FINAL  
ENVIRONMENTAL IMPACT REPORT  
SCH # 2023050241

# NORMANDIE CROSSING SPECIFIC PLAN PROJECT

**MARCH 2024**

### 2.2 COMMENT LETTERS AND RESPONSES

**DEIR Page 2-13, Exhibit 2-4: Conceptual Site Plan**  
(Previous Conceptual Site Plan dated December 15, 2022)

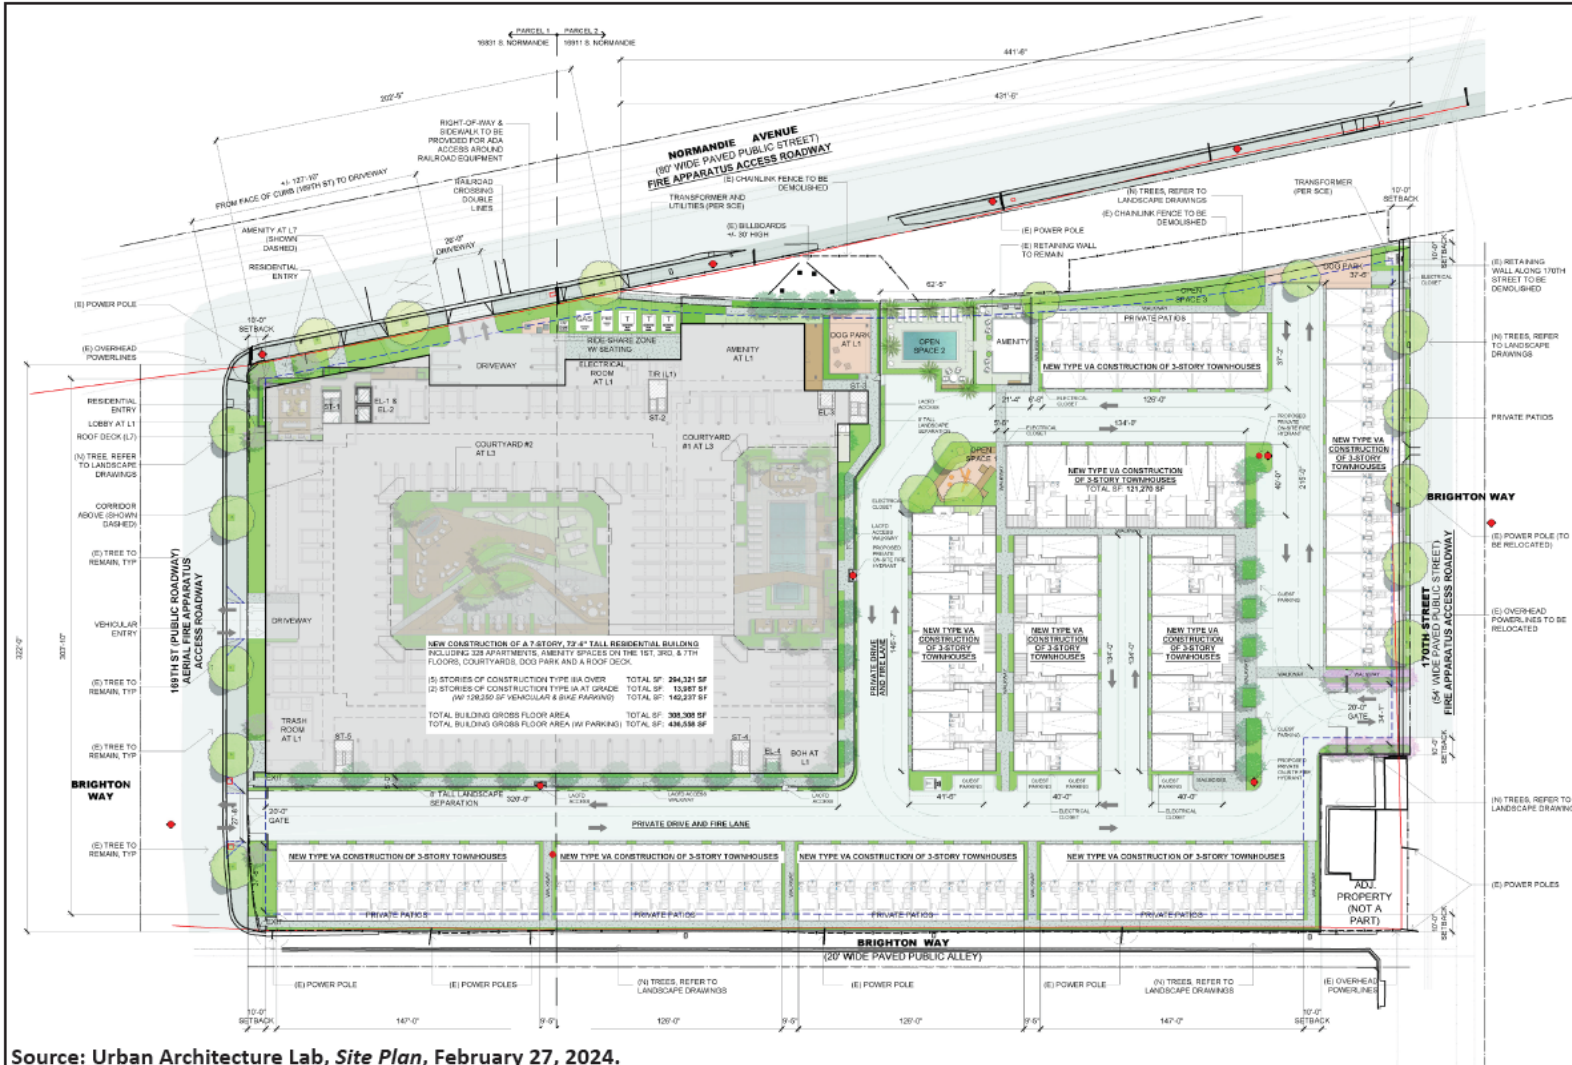
A1-2 This comment provides the Land Development Unit's comments on the DEIR. The comment states that the Project development must comply with all applicable code and ordinance requirements for construction, access, water mains, fire flows, and fire hydrants.

- The Applicant had several meetings with LACFD to address its concerns and revised the Conceptual Site Plan. According to the Applicant, these plans have been reviewed and approved by the LACFD Fire Prevention Division. As such, no further response is necessary.

(Revised Conceptual Site Plan dated February 27, 2024)

The multi-family residential development proposes two types of residential uses: an apartment building with 328 DU at the Project site’s northern portion; and 75 townhome-style units within ~~nine~~ ten buildings; see **Exhibit 2-4: Conceptual Site Plan**.
